Z-39
(2015)

ZONING SITE PLAN

PETITION NO.: Z-39

ZONING COMMENTS:

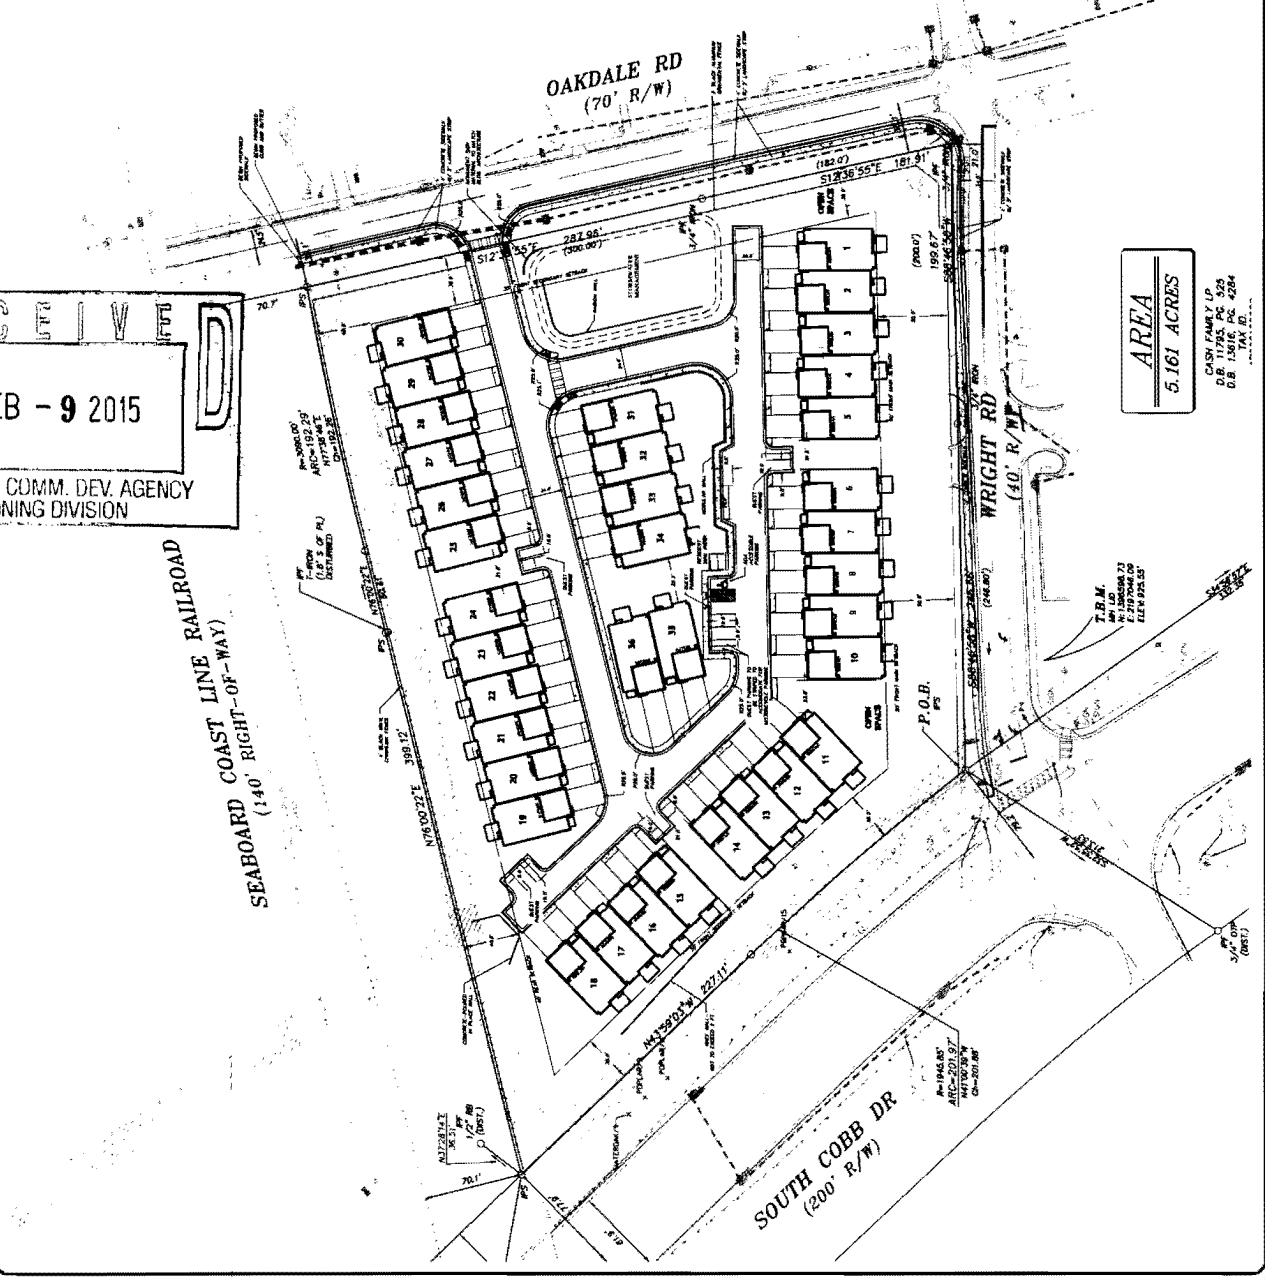
- Provide comprehensive hydrology/stormwater controls to include development of out parcels.
- Submit all proposed site improvements to Plan Review.
- Any **spring activity** uncovered must be addressed by a qualified geotechnical engineer (PE).
- Structural fill _____ must be placed under the direction of a qualified registered Georgia geotechnical engineer (PE).
- Existing facility.
- Project must comply with the Water Quality requirements of the CWA-NPDES-NPS Permit and County Water Quality Ordinance.
- Water Quality/Quantity contributions of the existing lake/pond on site must be continued as baseline conditions into proposed project.
- Calculate and provide % impervious of project site.
- Revisit design; reduce pavement area to reduce runoff and pollution.

INSUFFICIENT INFORMATION

- No Stormwater controls shown _____
- Copy of survey is not current – Additional comments may be forthcoming when current site conditions are exposed.
- No site improvements showing on exhibit.

1. This parcel is bounded by Oakdale Road to the east, Wright Road to the south, South Cobb Drive to the west and the Railroad to the north. The entire site drains to the east to an existing culvert under Oakdale Road. This culvert has been extended partially through the site. This conveyance drains approximately 75 acres from the drainage basin to the north of the railroad. To accommodate the proposed layout, the existing pipe system will need to be relocated and sized to accommodate the onsite as well as offsite 100-year design flow. This will require a stream buffer variance from Cobb County and GA EPD.
